11 July 2022

Planning Permit Application TP 136/2021

Proposed Use and Development of a Place of Assembly, Outbuilding, Display of Signage, and Development of Land

Lot 1, TP164431R Mount Baimbridge Road, Hamilton 3300

Drawing
PROPOSED SITE PLAN

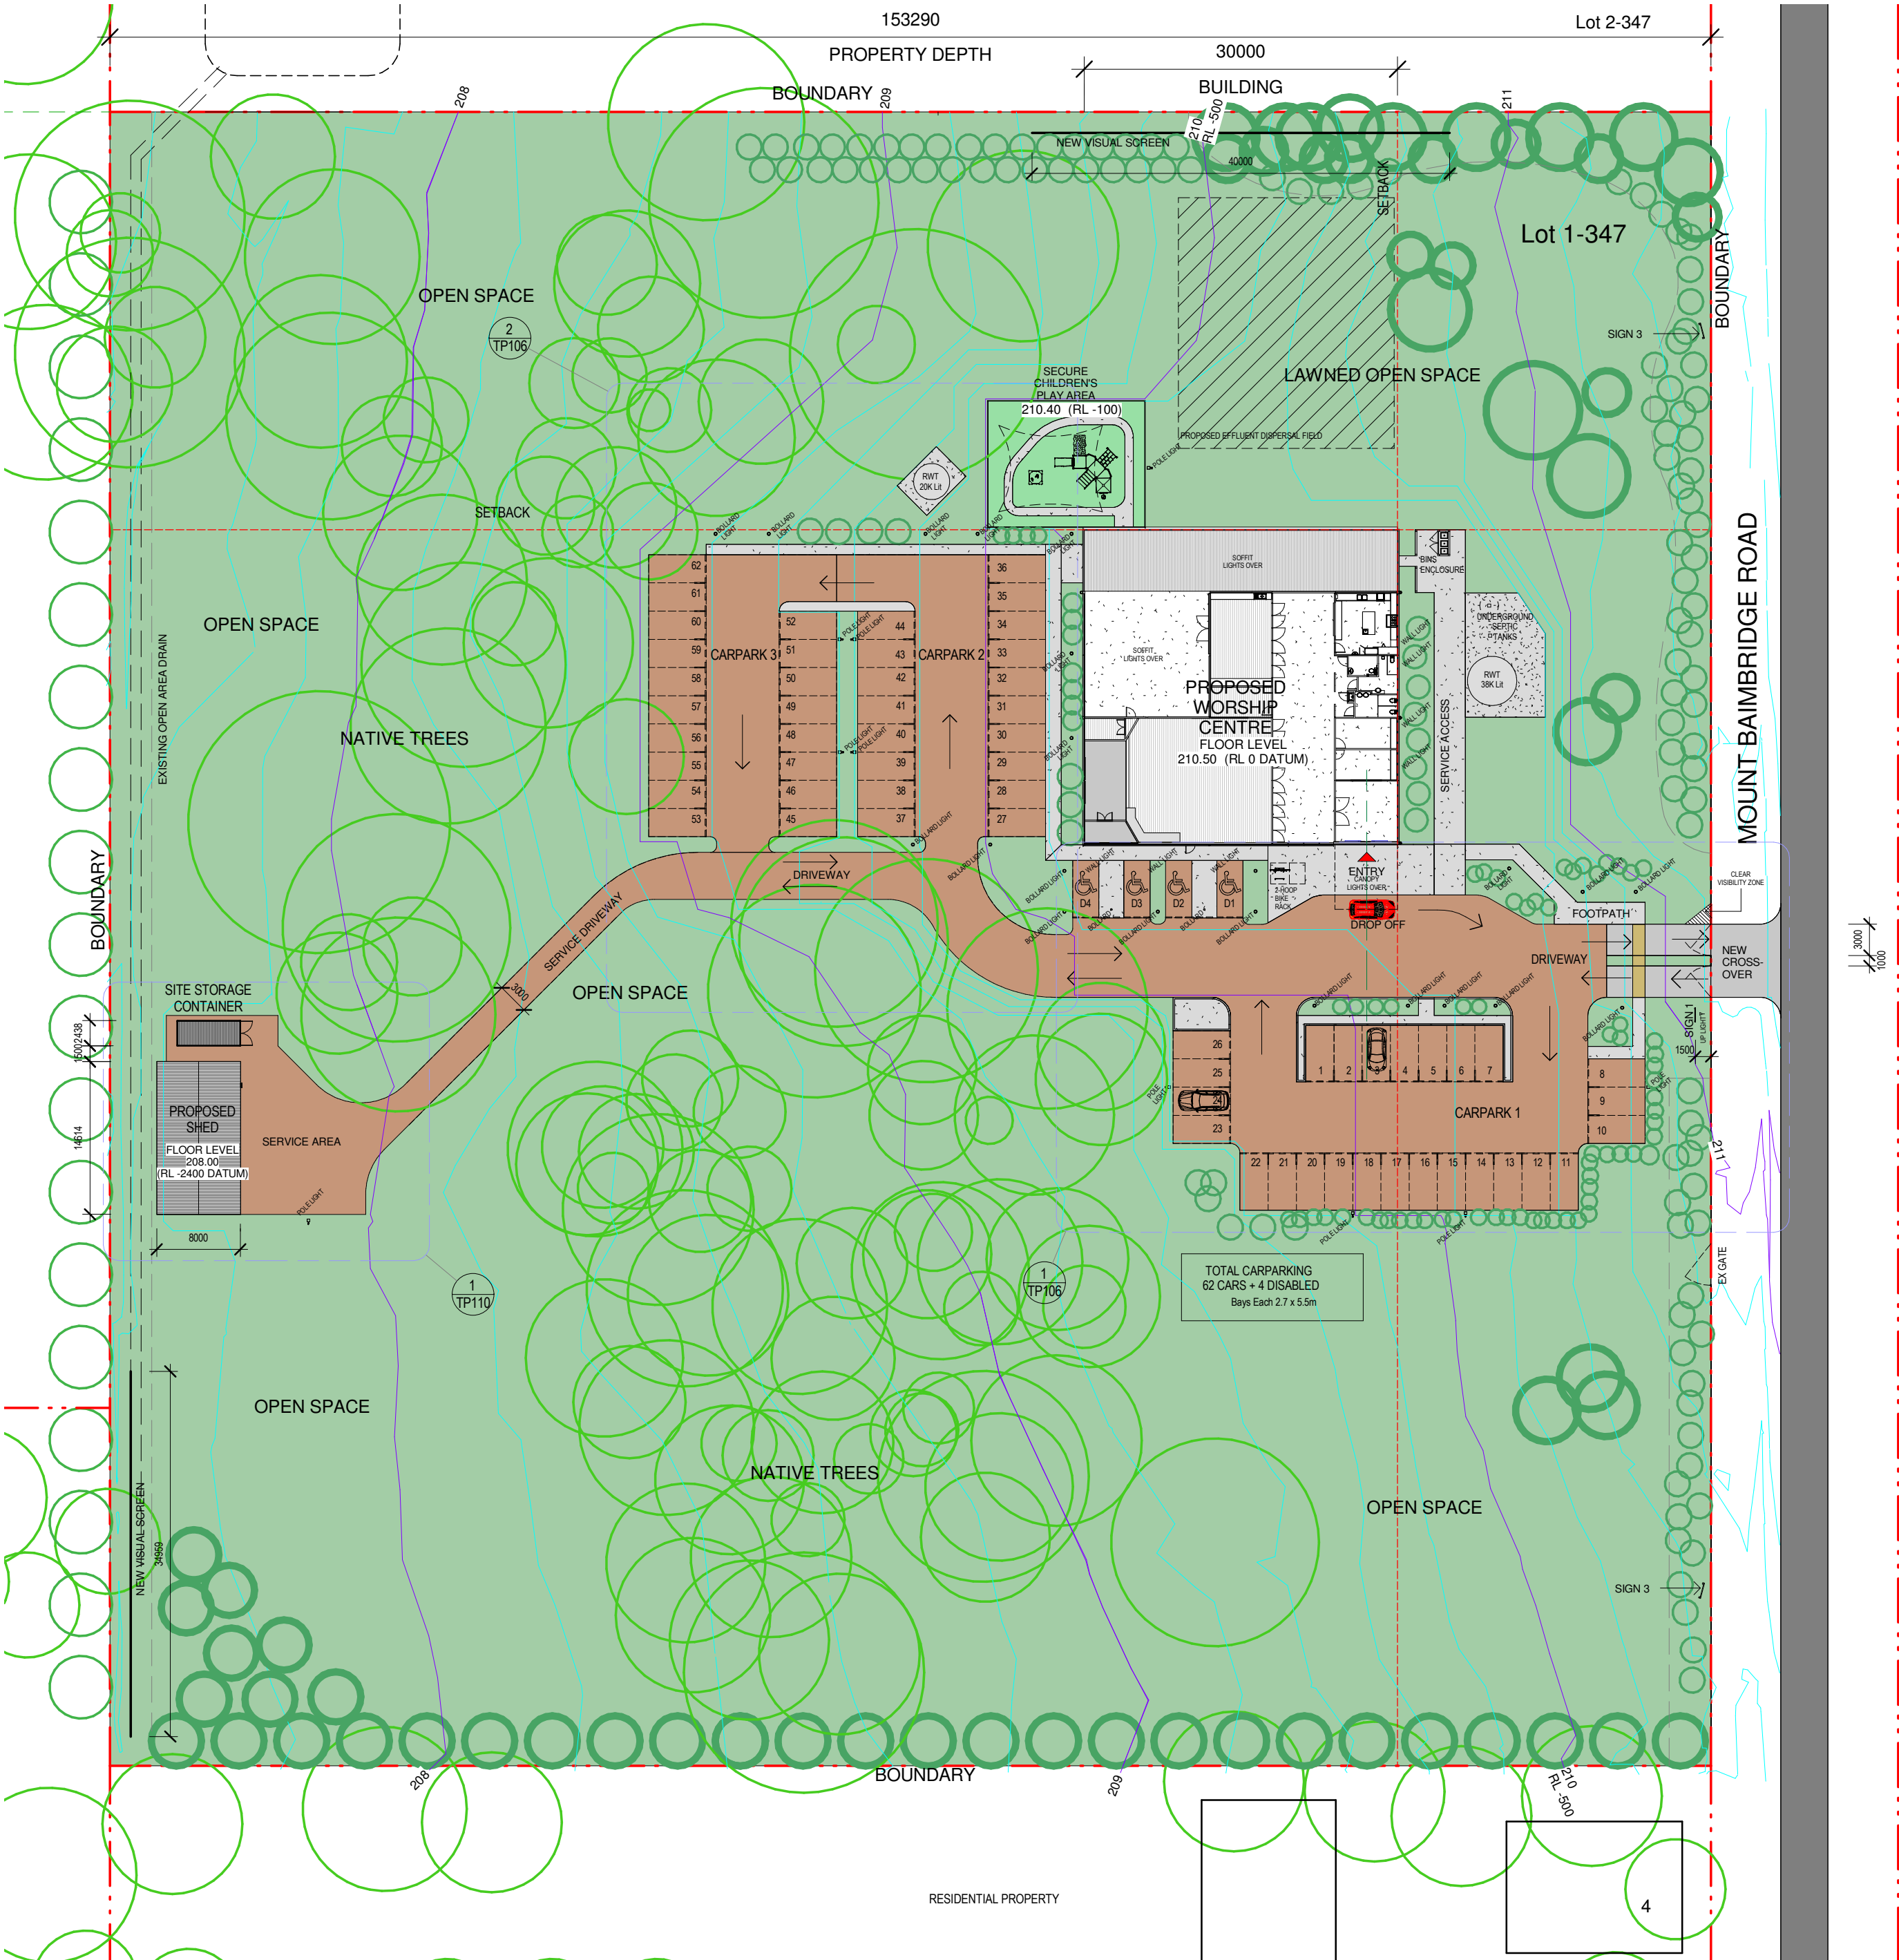
8. Amended Plans drawn to scale and include:

a. Widened access providing an on site verge for traffic to enter and exit the site safely

b. Refer to the revised Site Plan. Please note that a 40 metre privacy screen has been located upon the site plan to the northern boundary, and another screening the south-western neighbouring property to the extent of that boundary. However, it should be noted that a replacement Colorbond fence to the southern boundary is being undertaken from the eastern boundary for 40 metres, being 1.7 metres high alongside the residence, and that this is considered adequate by these neighbouring owners. The owners of the property to the west have stated that they do not wish to have additional visual screening, given that they have planted a row of native trees approx. four metres in from their boundary and therefore no such screening will be erected alongside this boundary.

Note that there are revised drawings submitted with this letter, that reflect the advice given in the traffic report.

Drawing																																																																									
PROPOSED LANDSCAPE PLAN

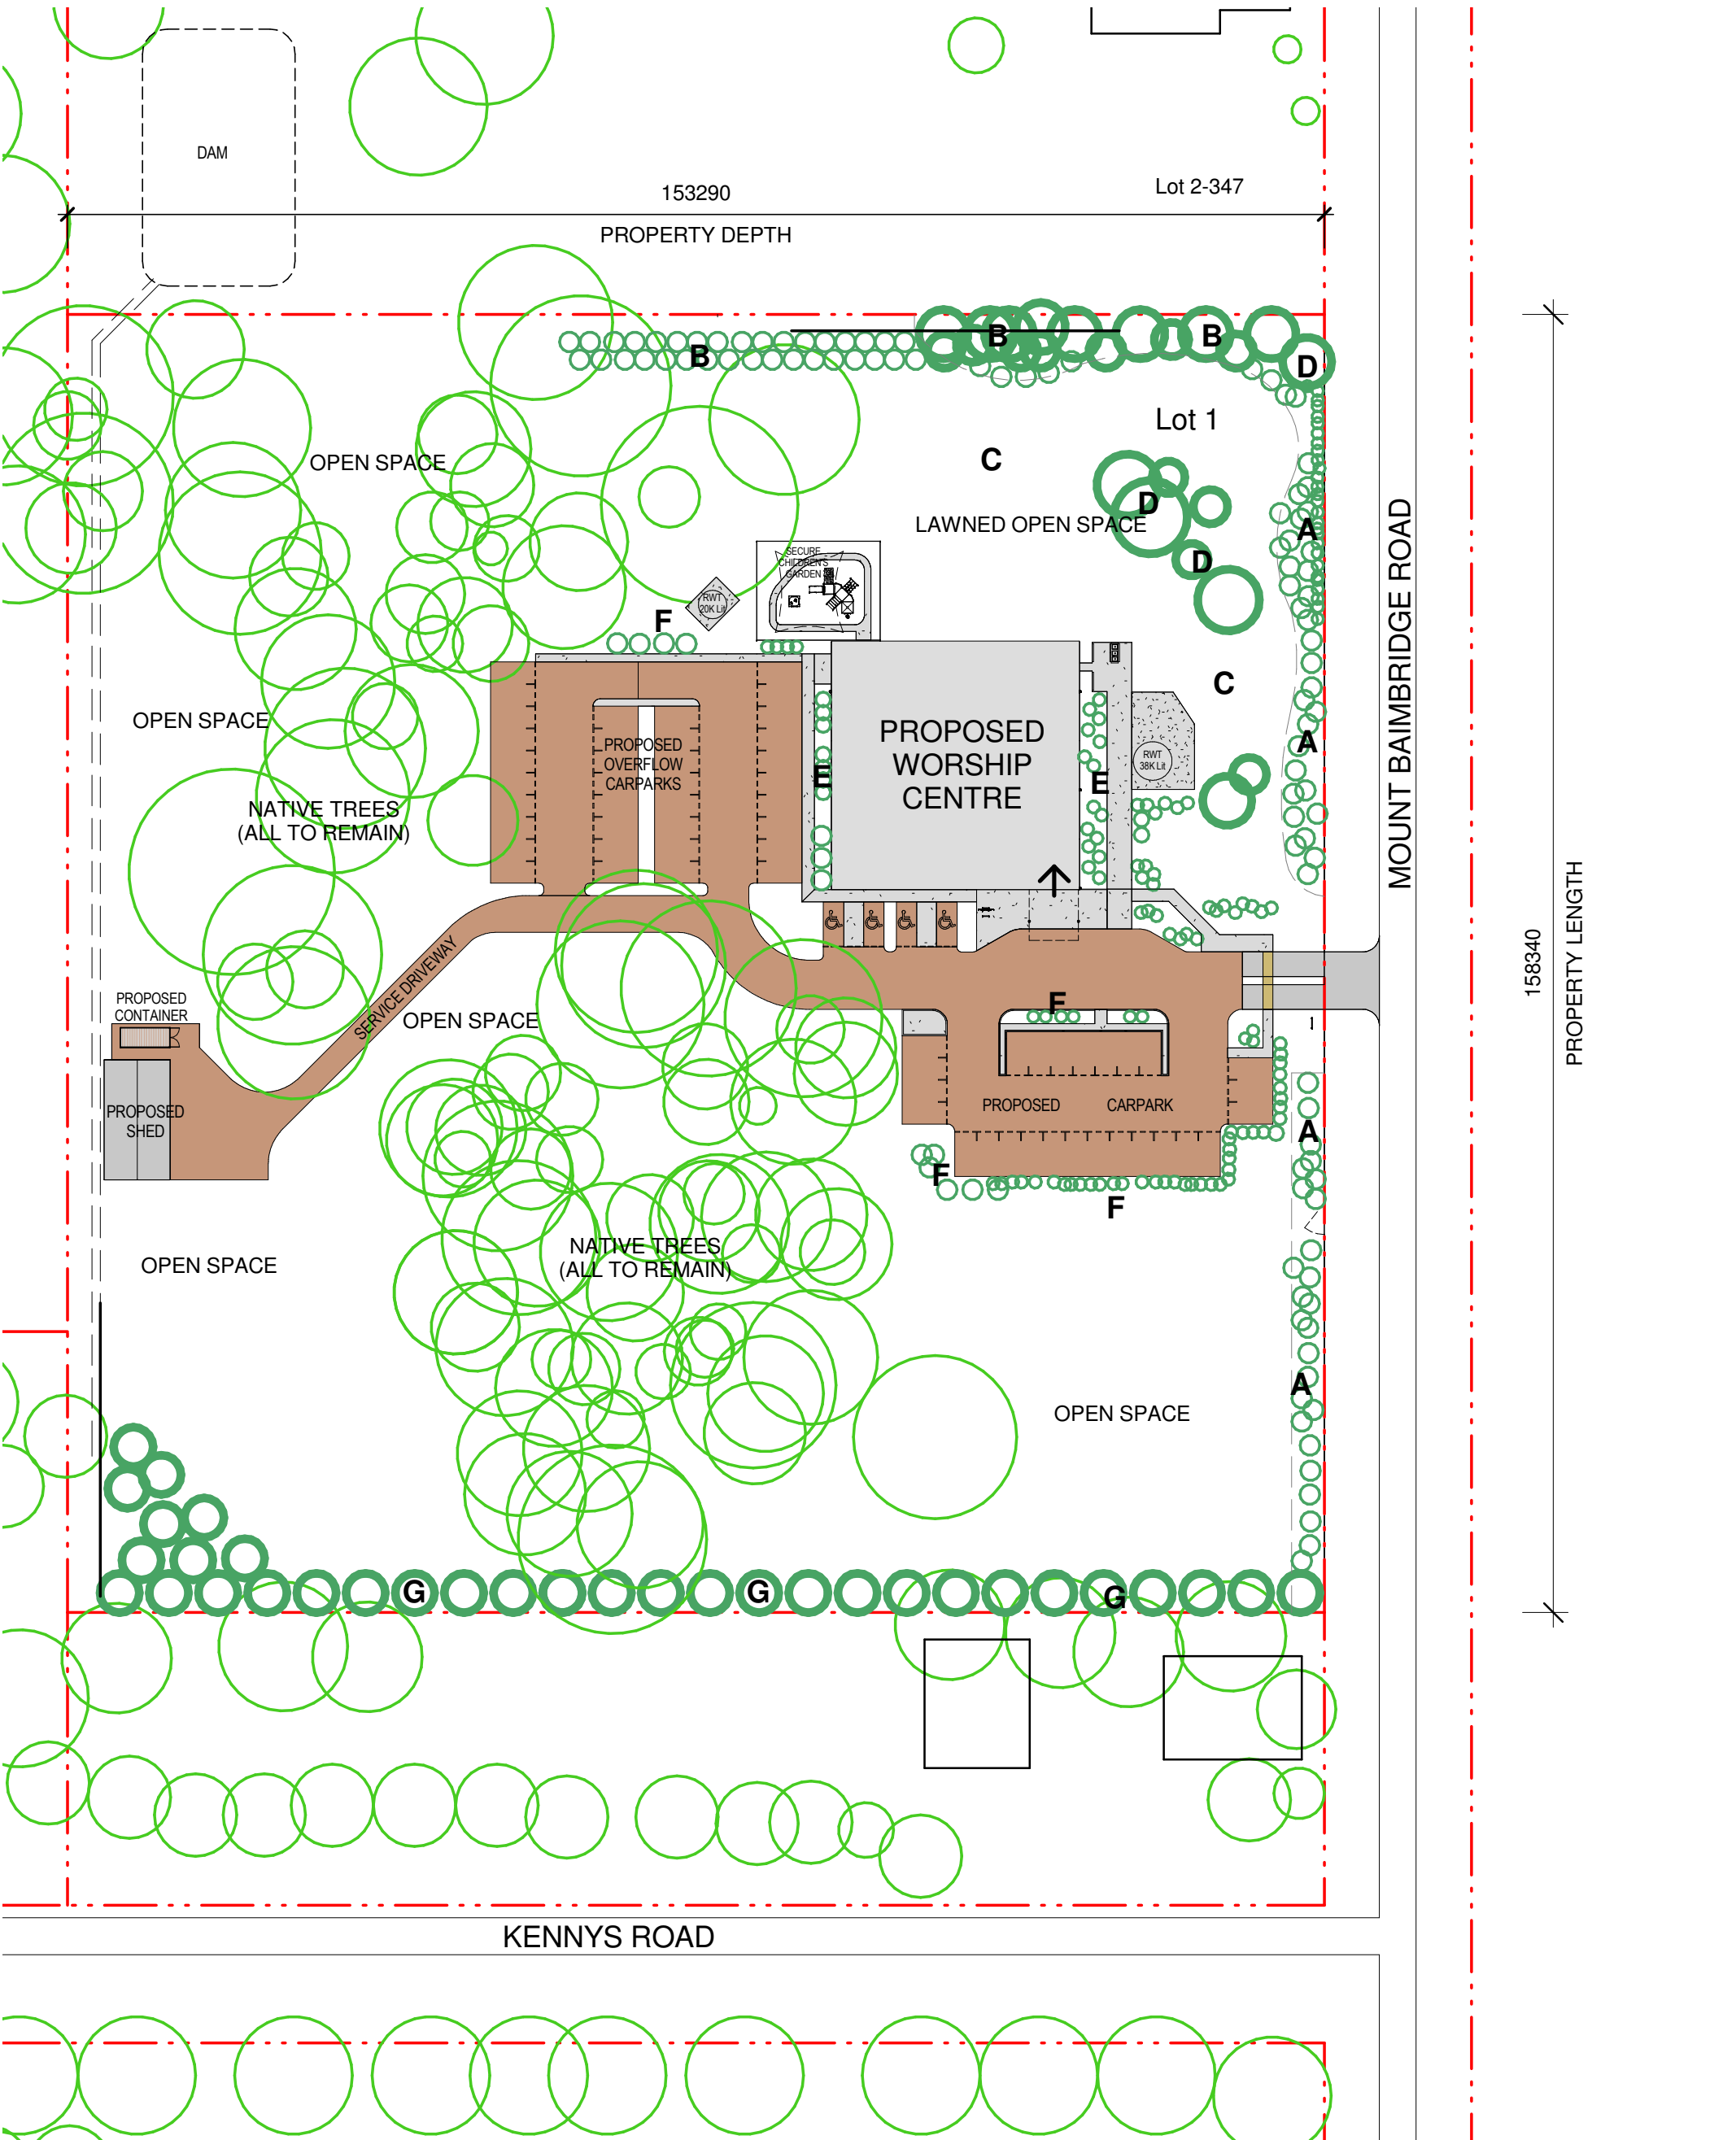
6. Amended Landscape plan to reflect amended site plans.

Refer to revised Landscape Plan, amended to match car park amendments resulting from Traffic Engineering Assessment.
